# Scientific Analysis/Calculation Administrative Change Notice

1. Document Number:	ANL-NBS-HS-000039	2. Revision:	02	3. ACN:	01
4. Title:	Saturated Zone In-Situ Testing				
5. No. of Pages Attached:	129

Figure F-46. Geochemistry Depth Profiles of Major Cations and Anions (upper) and Minor Cations (lower) in Boreholes 19D and 19IM1

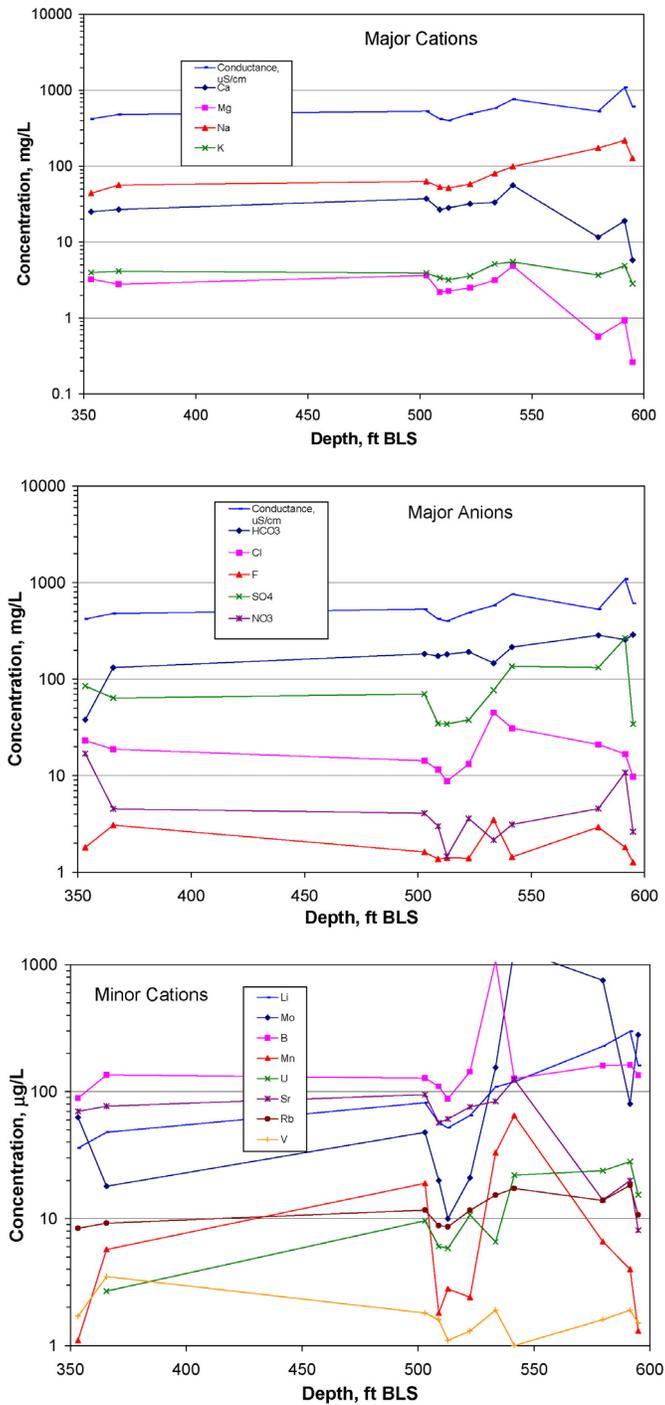
F-90	Revised the figure so that there are no spaces between rectangles representing layers.				
F-91	Changed “10.3 m/day” to “10.4 m/day” – DOE Comment				
F-97, F-98, F-99, F-100	Replaced Figures F-46 to F-49 to improve readability of axes and improve formatting.				
G-3	Changed top figure on this page so that all lines are bold/dark – DOE Comment				
G-6	Removed a row from this table that contained “Grain diameter in nonadvective layers”, which was always listed as N/A – DOE Comment				
G-9, G-12, G-13	Inserted “Insets show details of halide and FBA responses near their peak concentrations” in the notes to Figures G-3, G-5, and G-6 – DOE Comment(s)				
G-19	Changed “a = 0” to “c = 0” – DOE Comment

Figure G-32. MULTRAN Model Matches to the 22S Single-well Tracer Test Breakthrough Curves using the Diffusion-into-Grains Conceptual Model

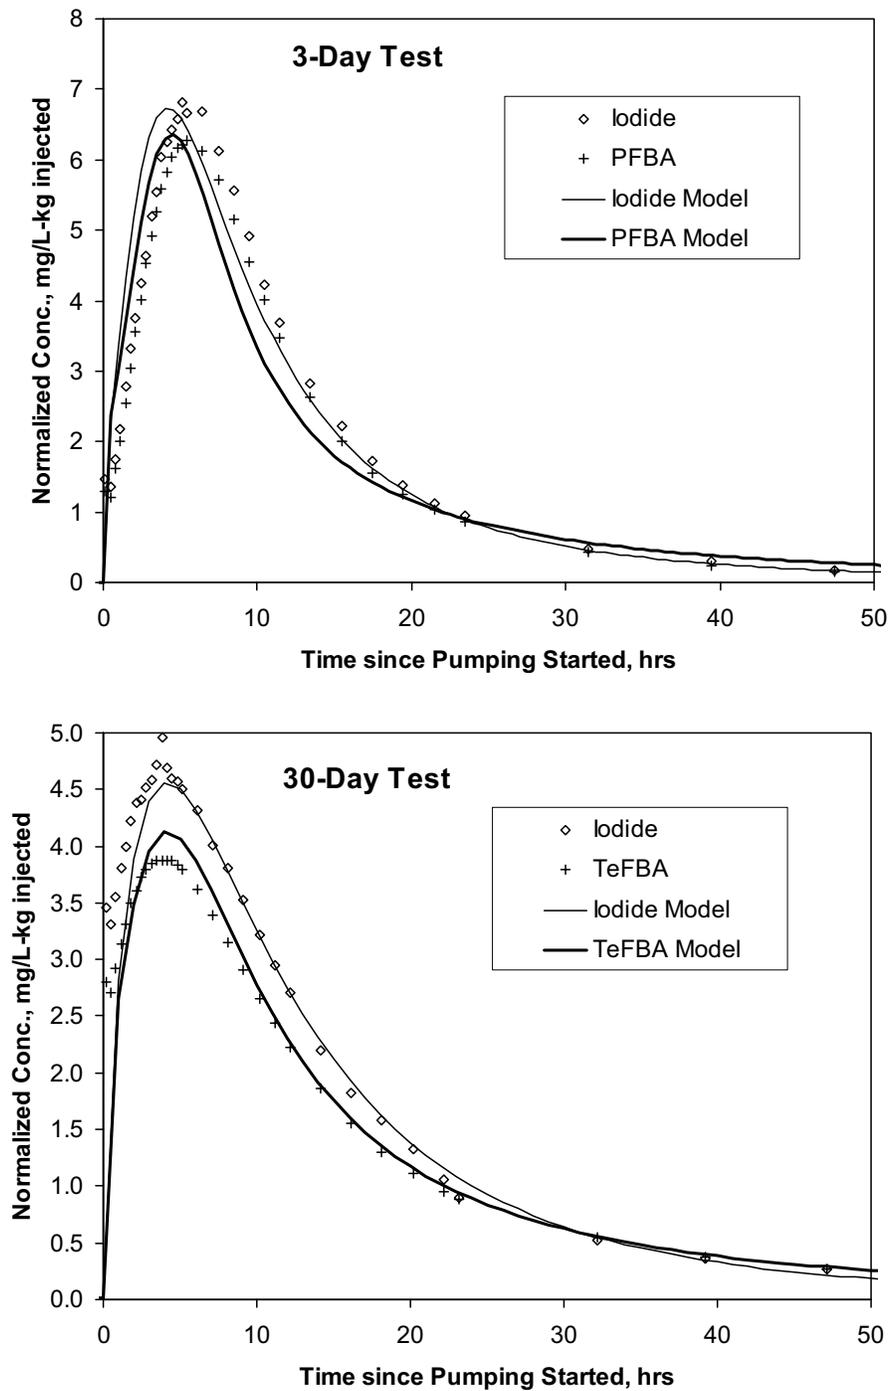
7. Affected Pages	8. Description of Change:
vii, viia	Editorial changes to titles of Appendices F and K. - Title change to Appendix F was a DOE Comment.
xx	Figure G-32 caption changed from "diffusion-into-blocks" to "diffusion-into-grains"
xxvi	Added "Groundwater" to the beginning of the table titles for Tables 6.5-5 and 6.5-6
xxviii	Added "Groundwater" to the beginning of the table titles for Tables G-8, G-9, and G-10. Also changed "diffusion-into-blocks" to "diffusion-into-grains" in title for Table G-11.
1-1	'BSC 2004 [DIRS 177390]' changed to 'SNL 2007 [DIRS 181650]'.
1-3	'BSC 2004 [DIRS 177390]' changed to 'SNL 2007 [DIRS 181650]' and 'BSC 2004 [DIRS 170042]' changed to 'SNL 2007 [DIRS 181006]'.
6-3	Added note to Figure 6.1-1.
6-17	Centered Figure 6.1-10 and changed DTN and DIRs number for the LA FEP list. Changed "model report" to "analysis report". Added a period after "table" (last word on page).
